ADDENDUM #001

Date: 6/4/2026

Blair Community Schools
Arbor Park Elementary School
Addition and Renovation
1717 Adams Street, Blair, Nebraska 68008

JJA Project: 3670
Drawings & Specifications
Dated: 5/18/2026

1 A6.3 LEVEL ONE FLOOR FINISH
3/16" = 1'-0"

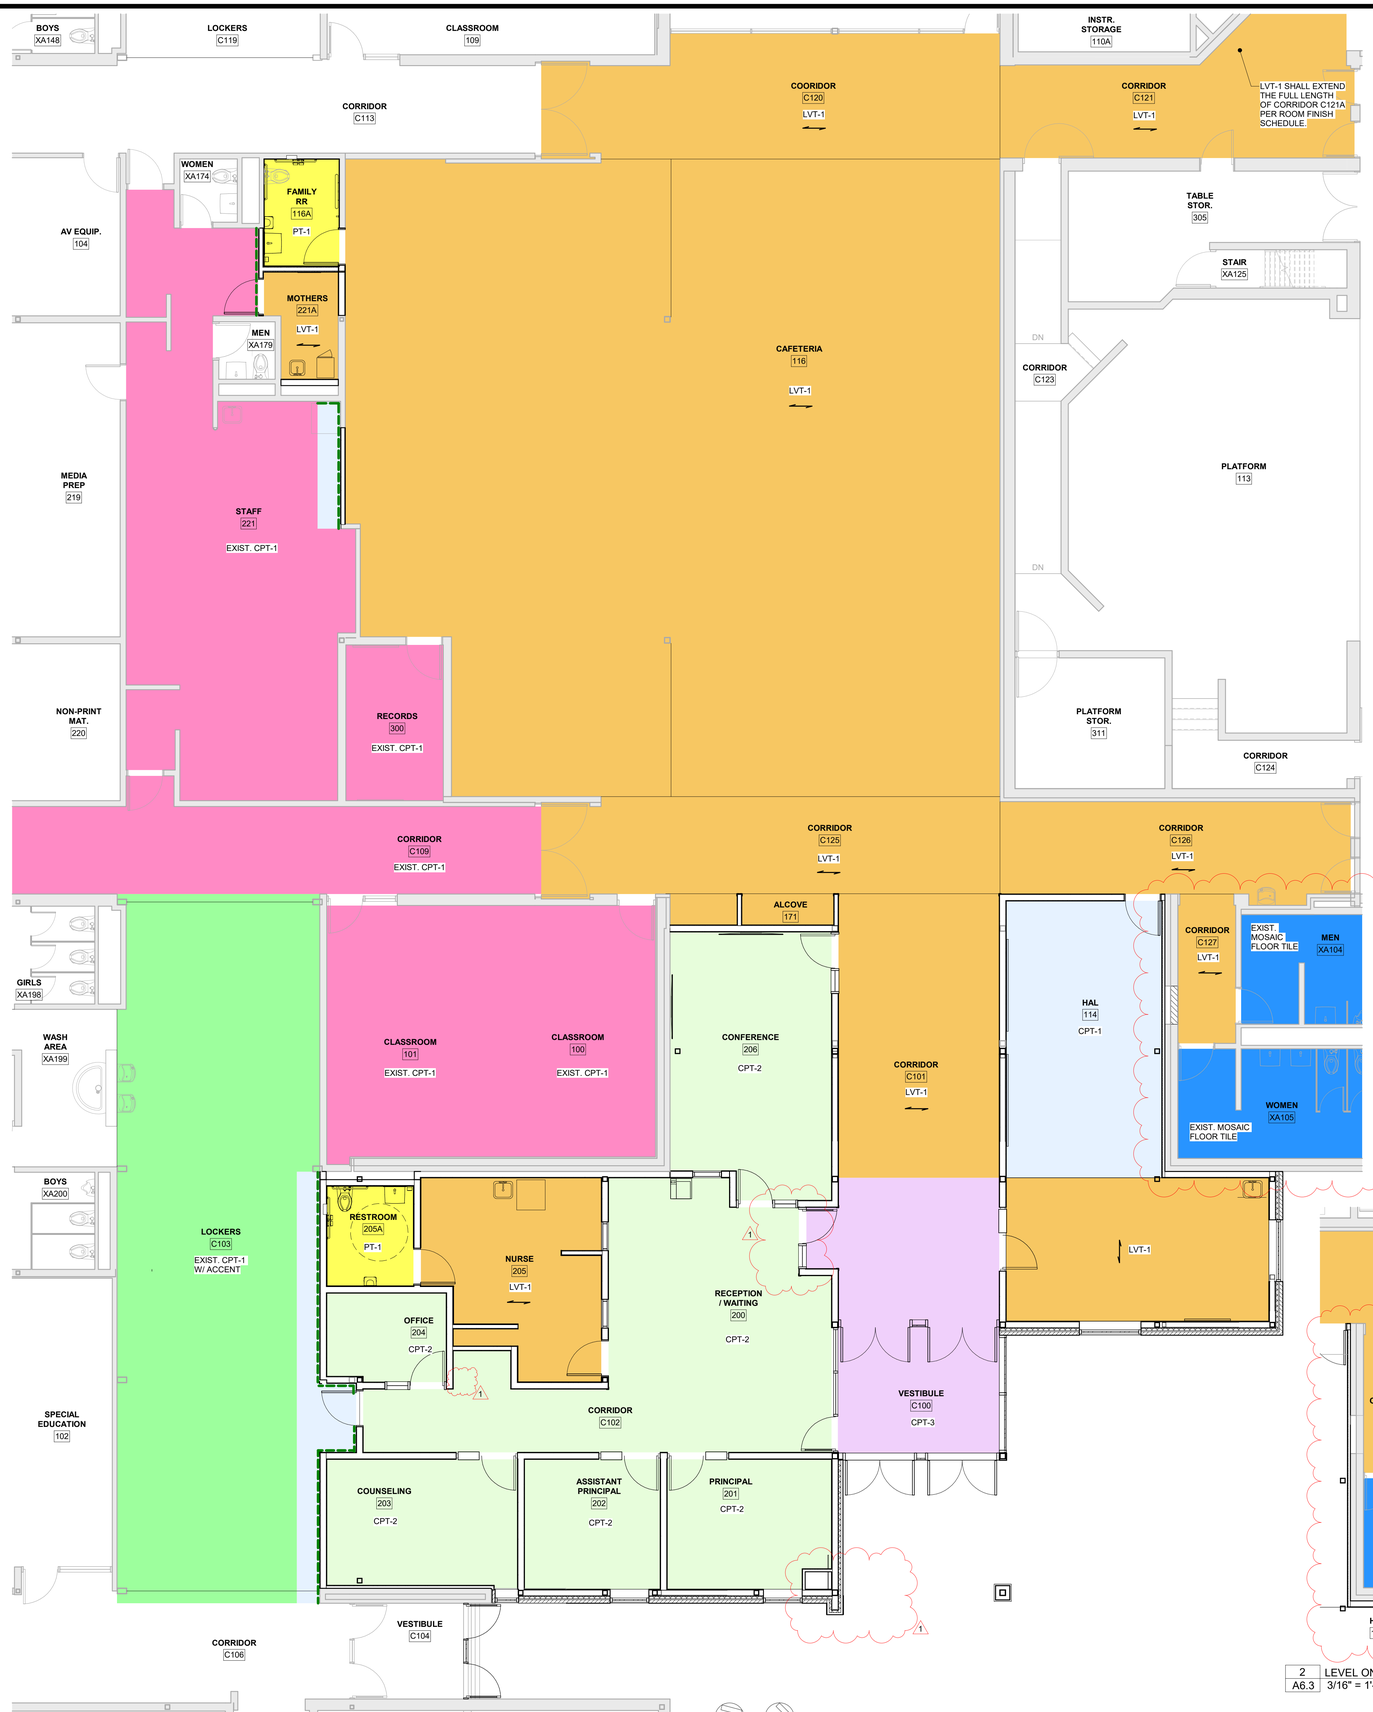
Item #29 Refer to Drawing A6.3 Level One Floor Finish Plan and the attached revised drawing sheet.
A. Refer to the revised 1/A6.3 Level One Floor Finish.
B. Refer to the revised 2/A6.3 Level One Floor Finish.

1 FOUNDATION PLAN
3/16" = 1'-0"

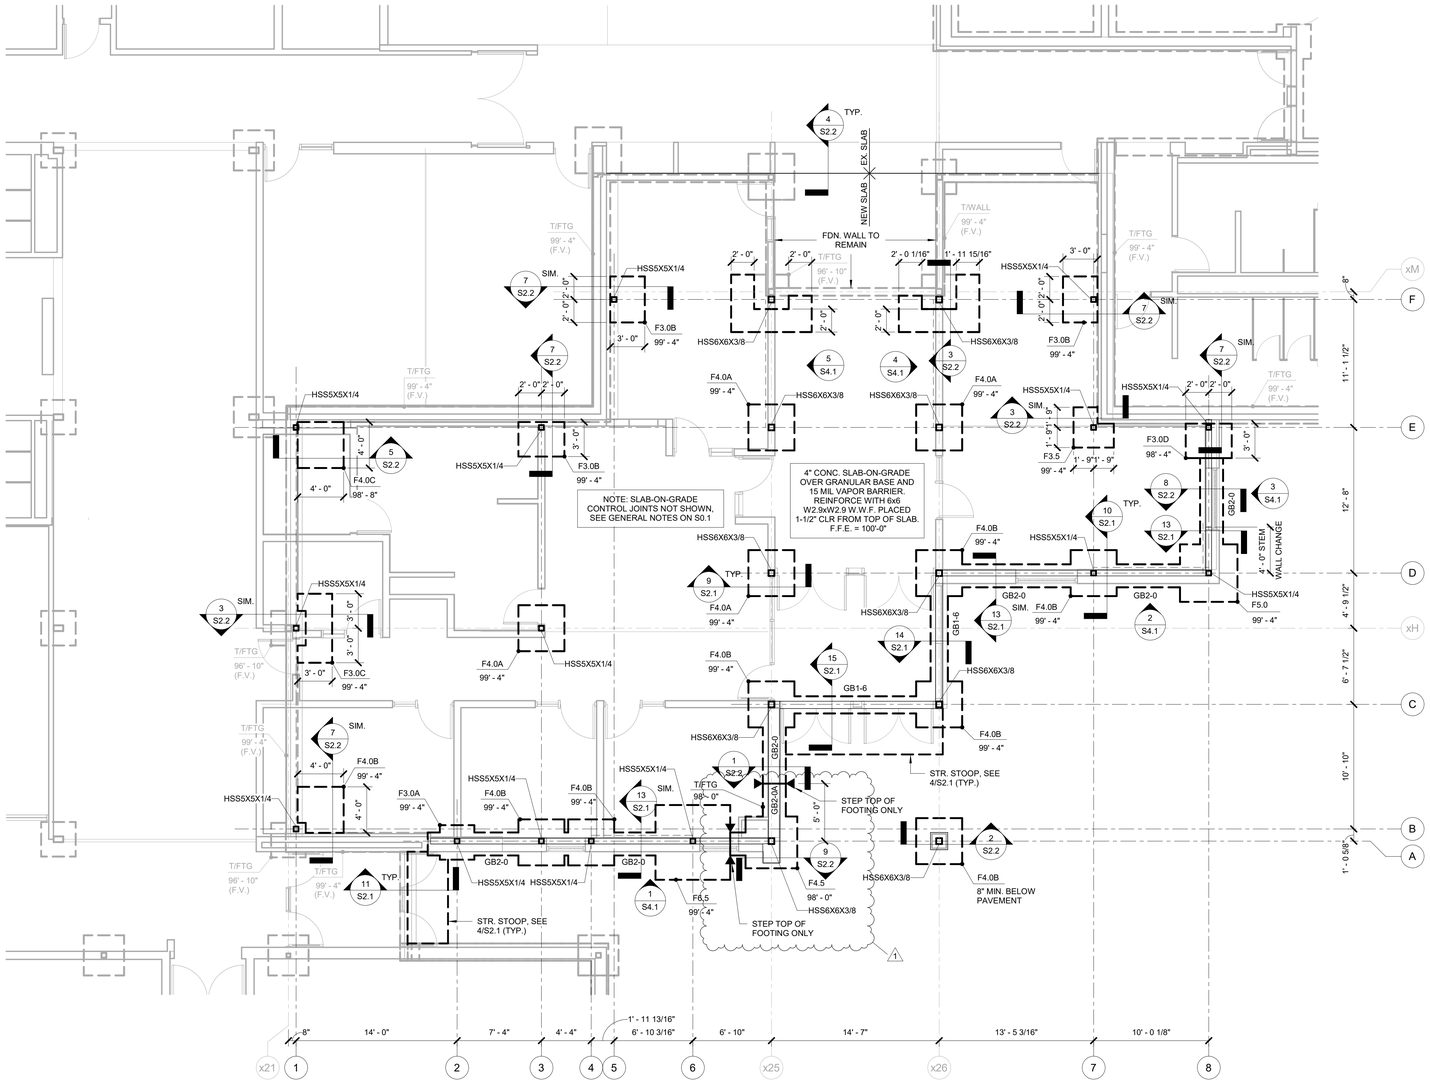
Item #31 Refer to Drawing S1.1 Foundation Plan and the attached revised drawing sheet.
A. Refer to the revised 1/S1.1 Foundation Plan.

1 ROOF FRAMING PLAN
3/16" = 1'-0"

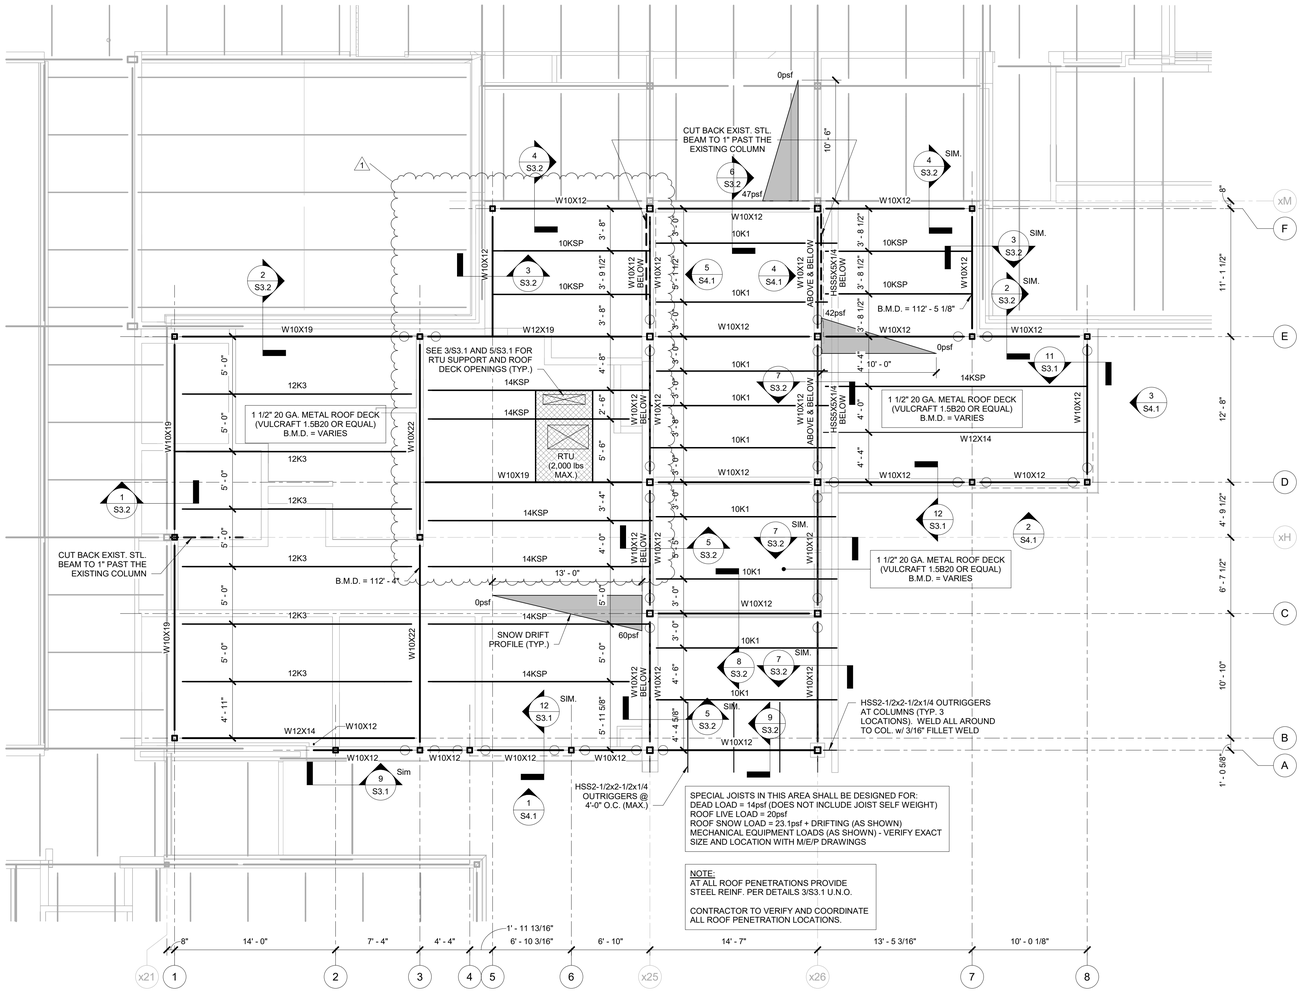
Item #32 Refer to Drawing S1.2 Roof Framing Plan and the attached revised drawing sheet.
A. Refer to the revised 1/S1.2 Roof Framing Plan.

5 SECTION
1" = 1'-0"

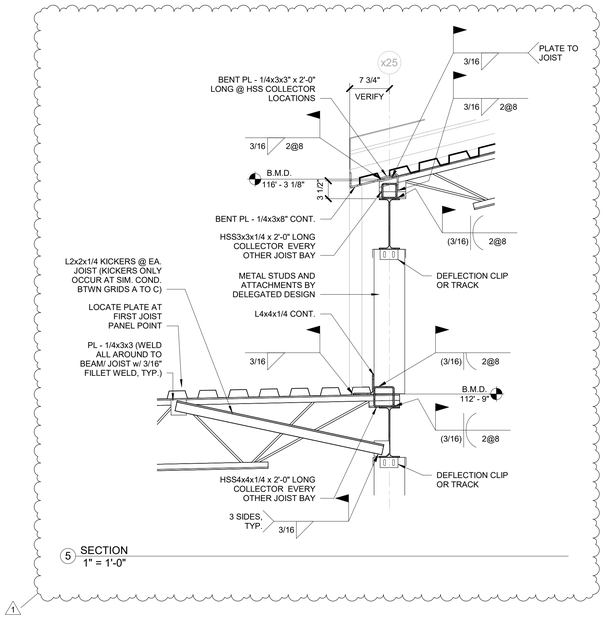
Item #34 Refer to Drawing S3.2 Framing Details and the attached revised drawing sheet.
A. Refer to the revised 5/S3.2 Section.

1 MD1.1 LEVEL ONE PLUMBING DEMOLITION PLAN
3/16" = 1'-0"

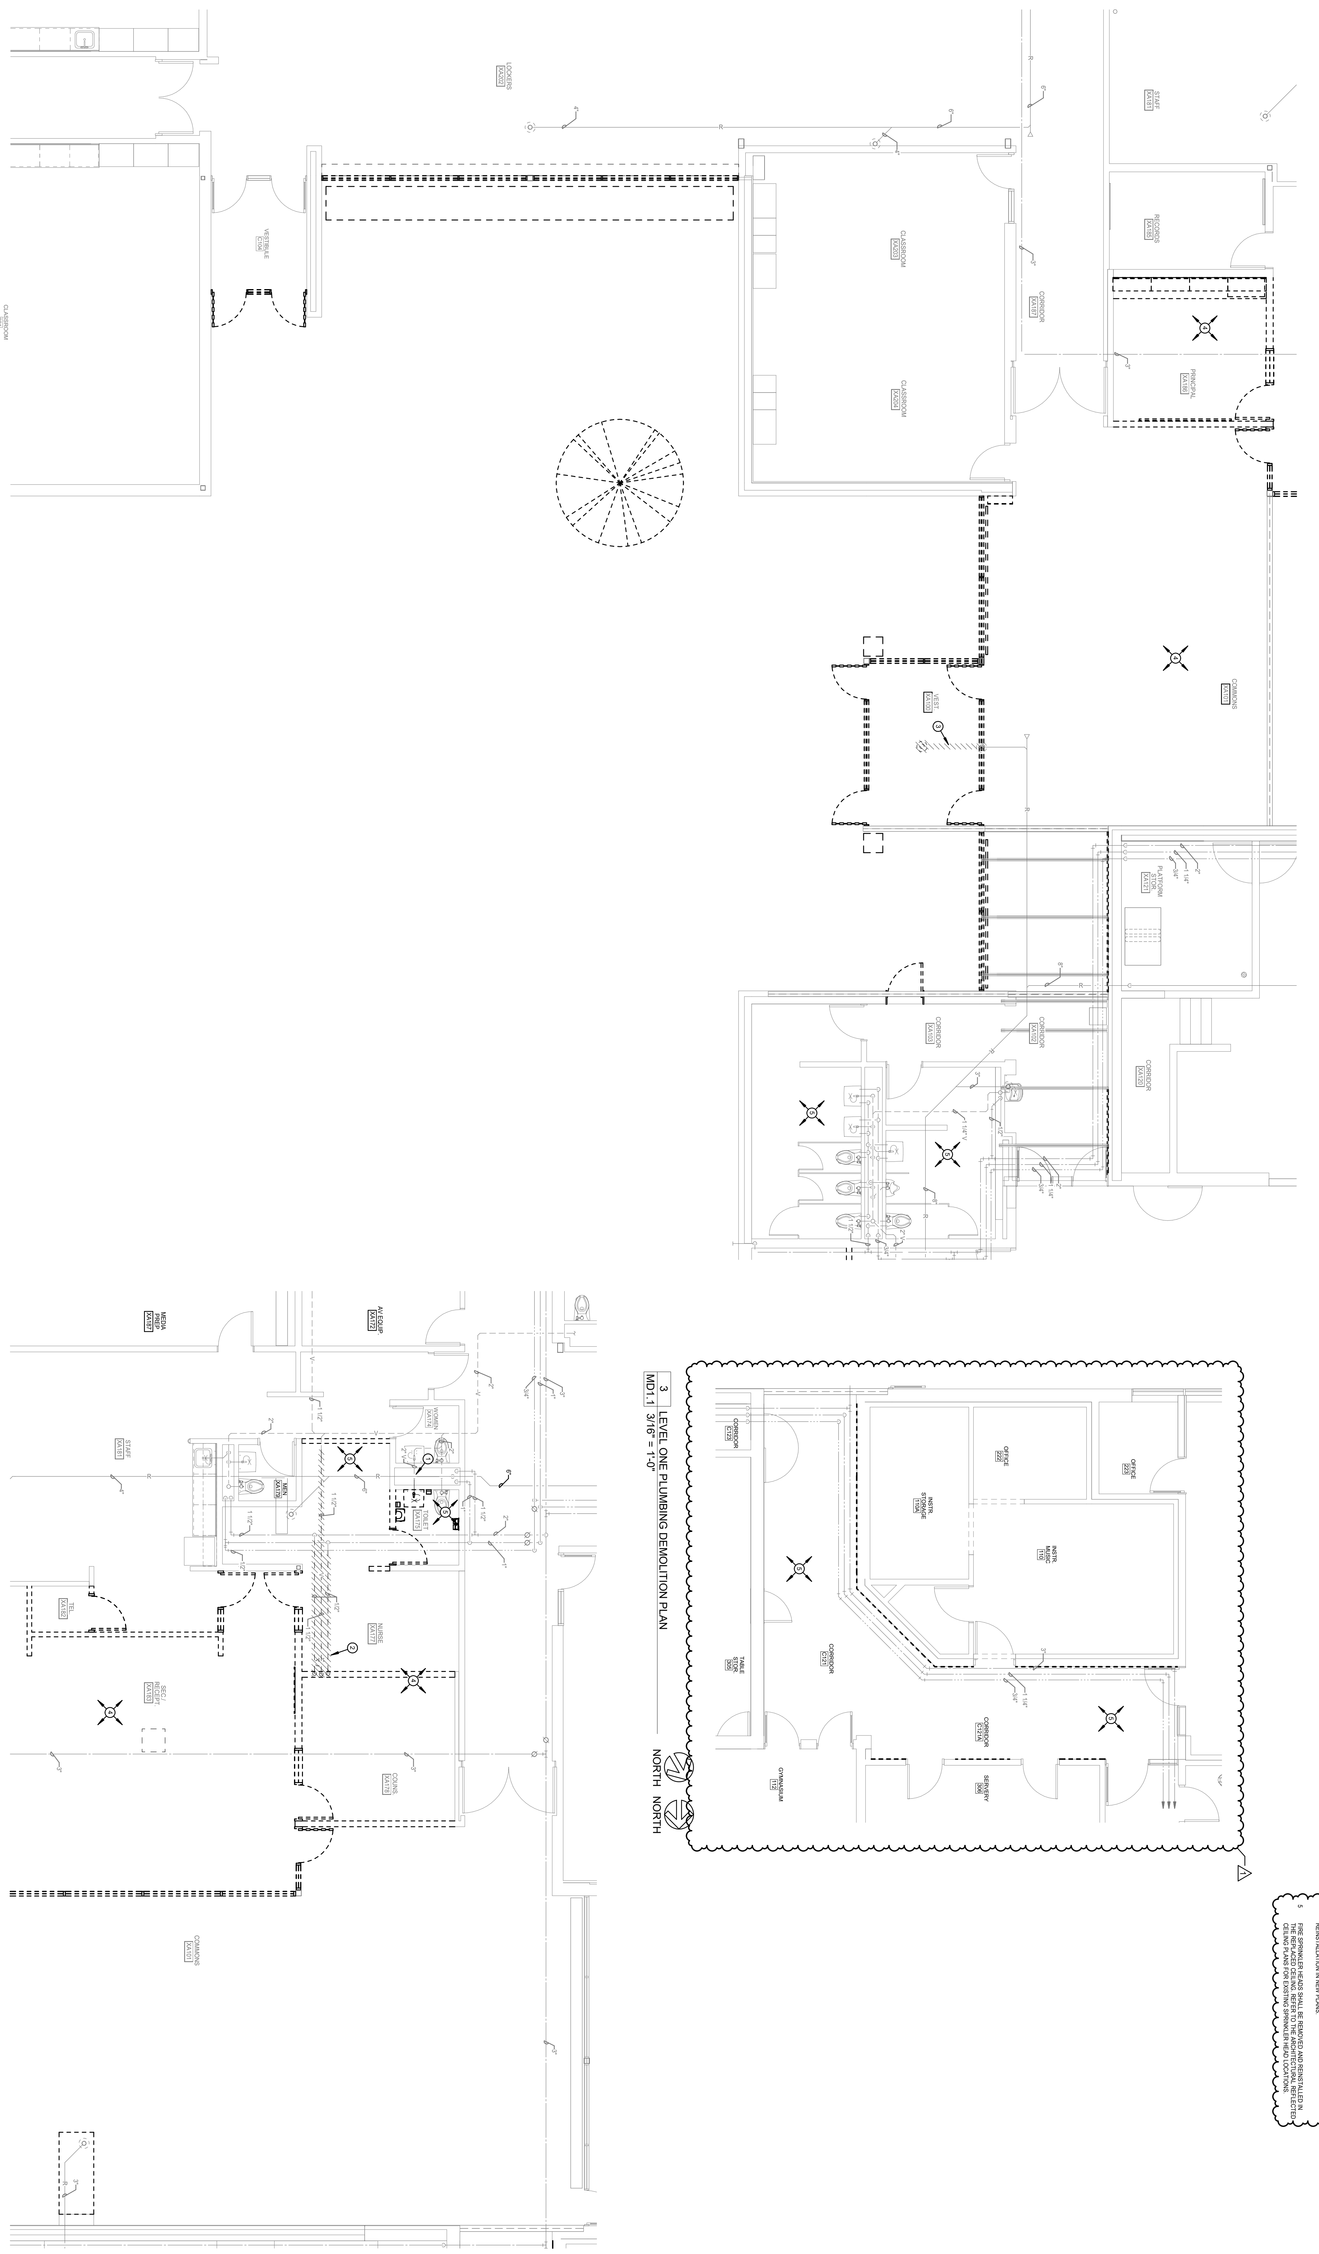
Item #38 Refer to Drawing MD1.1 Level One Plumbing Demolition Plan and the attached revised drawing sheet.
A. Updated sheet notes.
B. Added plumbing demolition plan view of corridor.
